Re: Mitchell Farms Council Comments

During our discussion with City Council in our first public hearing on November 25, 2019, we heard and listened to the concerns of the various council members that gave us feed-back on Mitchell Farms, our newest proposed development in Mansfield. We are hopeful that staff and Council will find our modifications to Mitchell Farms are consistent with Councils' objective to ensure the project will be developed to the same level of high quality exemplified by the surrounding developments. A summary of the changes is provided below:

## Updated North Boundary Screening:

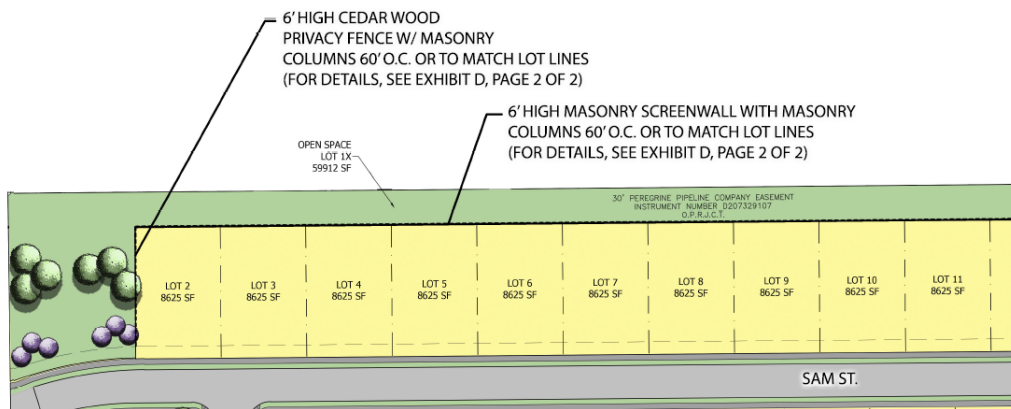
We have also been working with our neighbor to the north, the Living Church, on a more cohesive screening plan that would complement both proposed uses. We have eliminated the double fencing over the gas easement, removing the 30' dead space, and we are now proposing a 6' masonry wall with masonry columns along the rear lot lines of the homes abutting the Church. This will provide a lasting screening element and more usable land along the Churches border. It will also eliminate a 30' alley trapped between 2 fences that was a concern for us and the Church for both maintenance and safety.
